**Final Supplement
Final Environmental Impact Statement**

**BONNEVILLE POWER
ADMINISTRATION**

Northwest Montana/North Idaho Support and Libby Integration

August 1981

FIGURE 7
GEOLOGY AND SOIL HAZARDS
N. W. MONT./N. IDA. SUPPORT/LIBBY INTEG. PROJ.
80-3

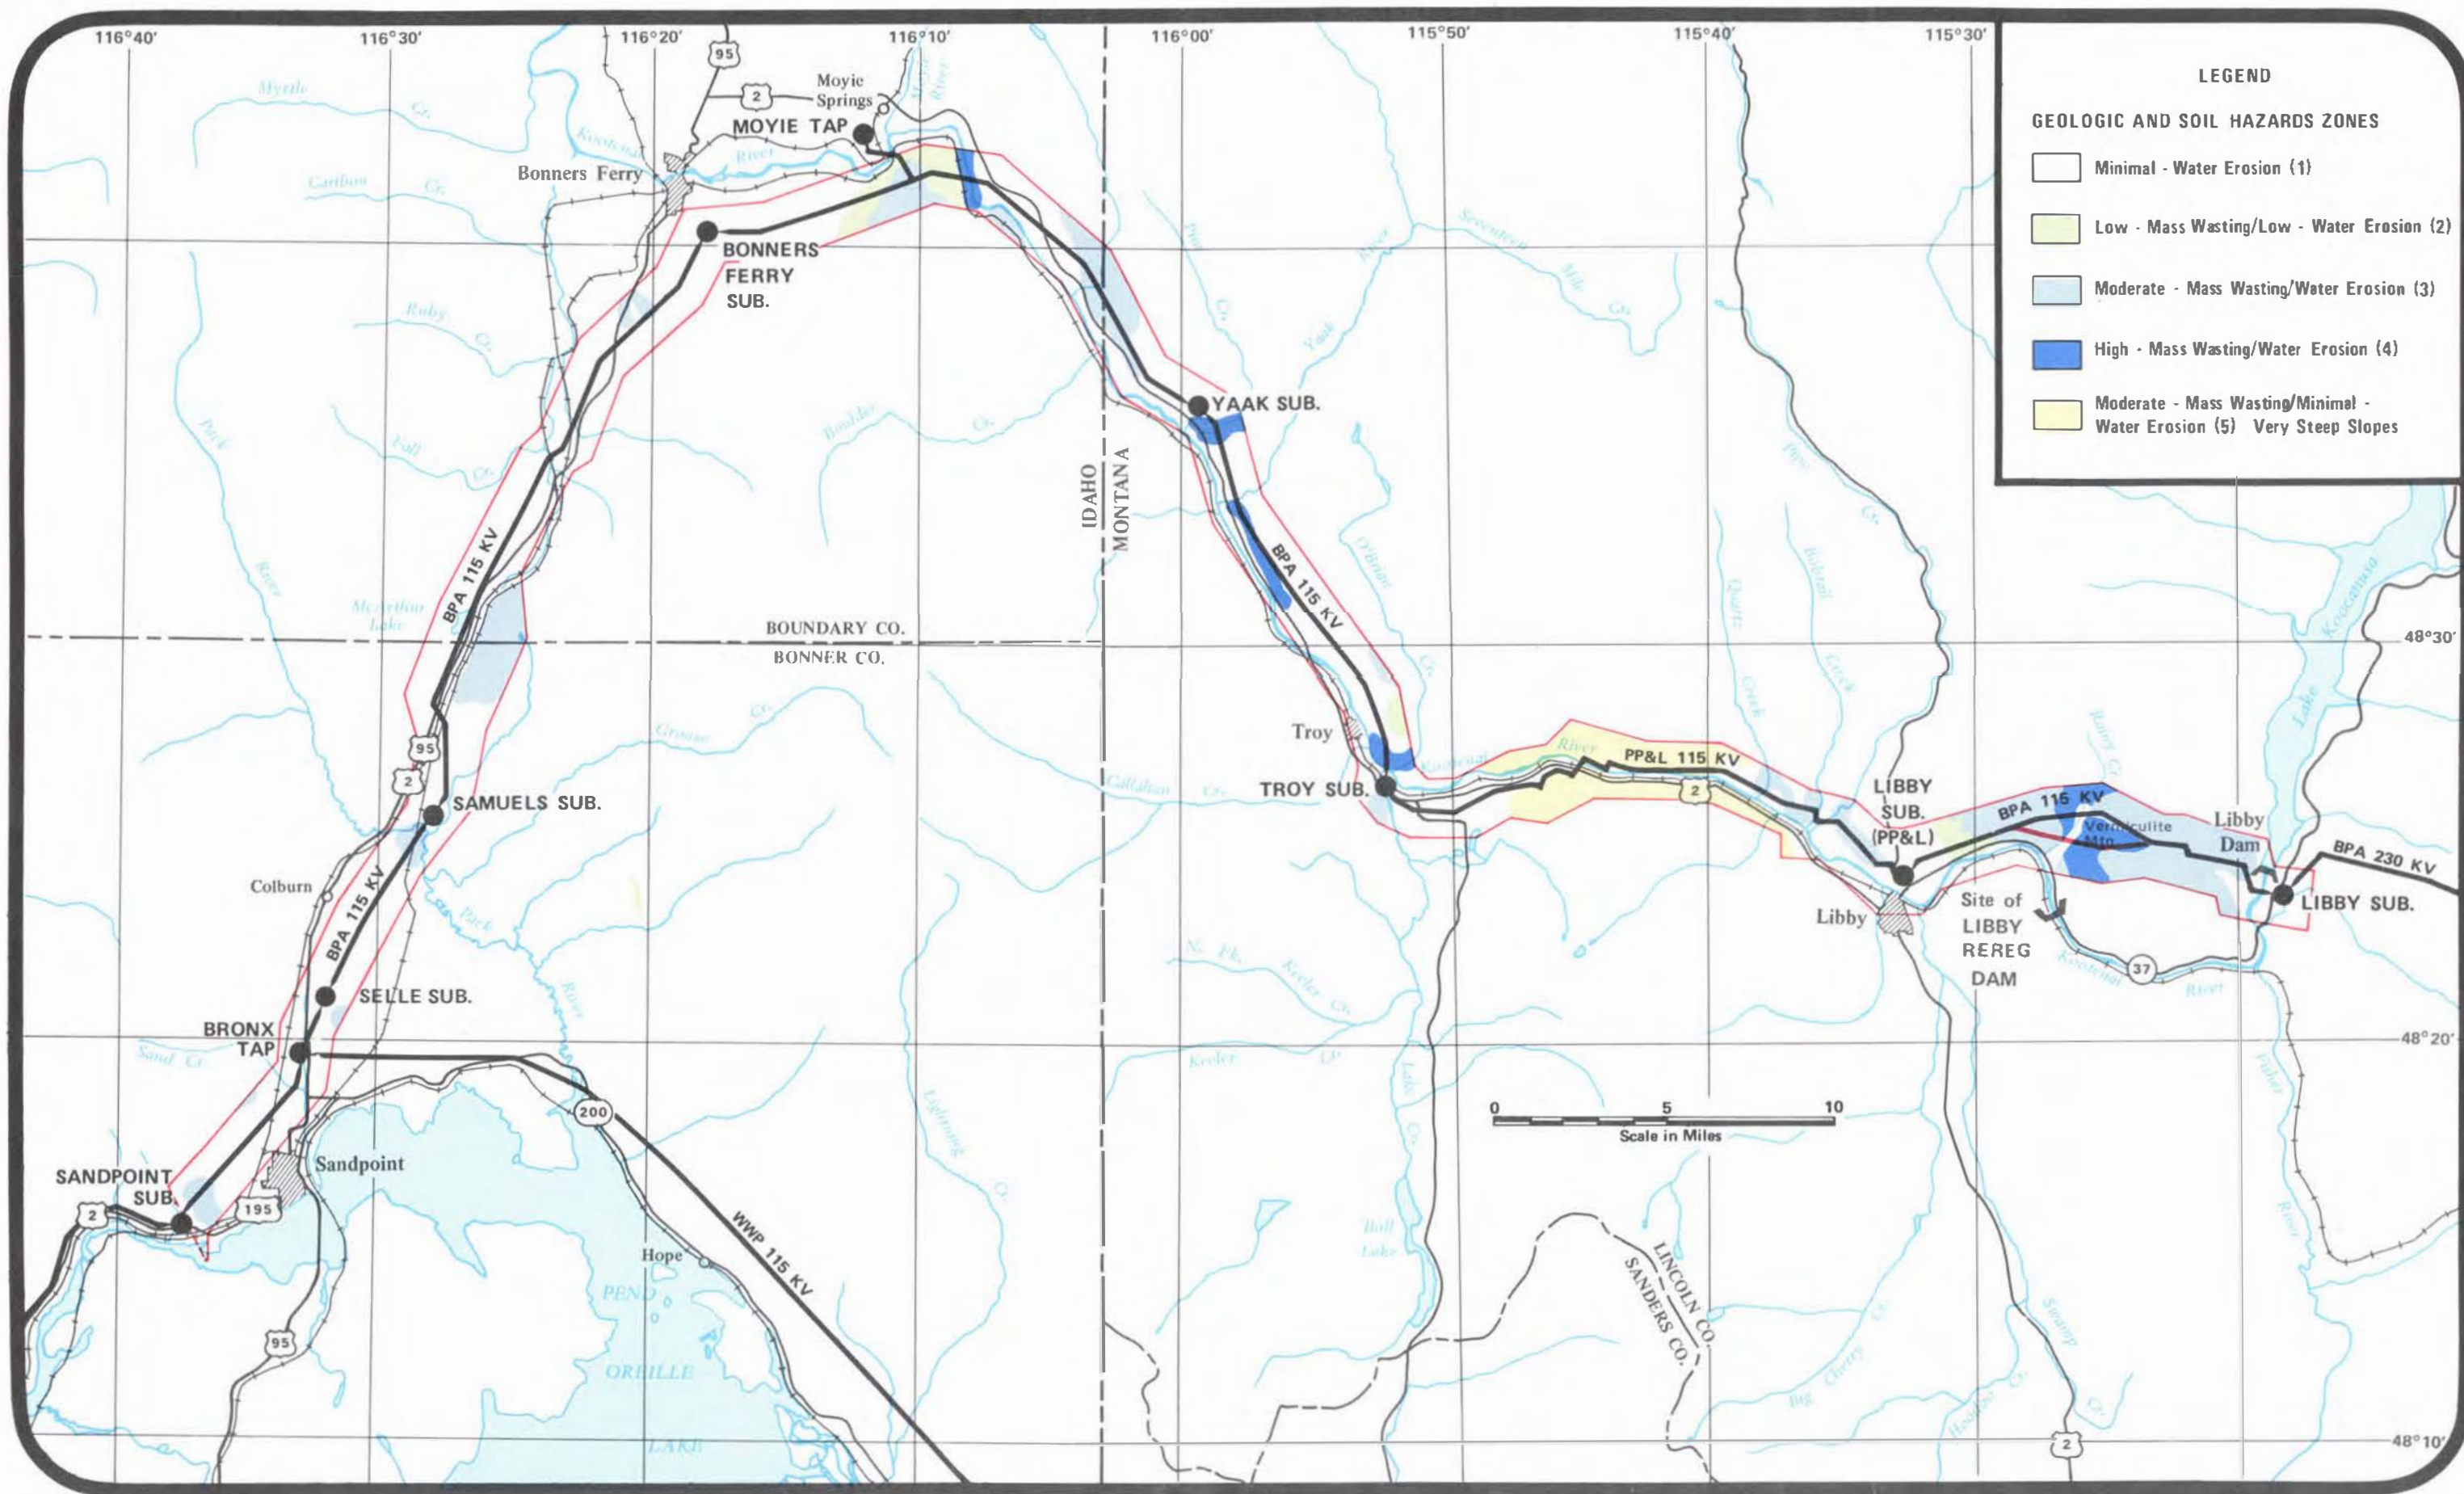
33. Comment: Our primary concerns are for stream crossings by the transmission line or access roads in areas of high hazard for erosion or mass wasting. The map in figure 7 shows that the transmission line crosses streams at several points in or adjacent to areas with high erosion hazard. This is contrary to the text on page 33 which says that crossings will not occur in such areas. These crossings include Pine Creek, Yaak River, and the Kootenai River above Moyei River and below O'Brien Creek. This discrepancy should be corrected. It would also be helpful if new or enlarged road crossings of streams were mapped. (U.S. Environmental Protection Agency) (DNRC made a similar comment)

Our primary concerns are for stream crossings by the transmission line or access roads in areas of high hazard for erosion or mass wasting. The map in Figure 7 shows that the transmission line crosses streams at several points in or adjacent to areas with high erosion hazard. This is contrary to the text on page 33 which says that crossings will not occur in such areas. These crossings include Pine Creek, Yaak River, and the Kootenai River above Moyei River and below O'Brien Creek. This discrepancy should be corrected. It would also be helpful if new or enlarged road crossings of streams were mapped.

Figure 7 does not appear to support the statement on page 33 that "streams are located away from the right-of-way."
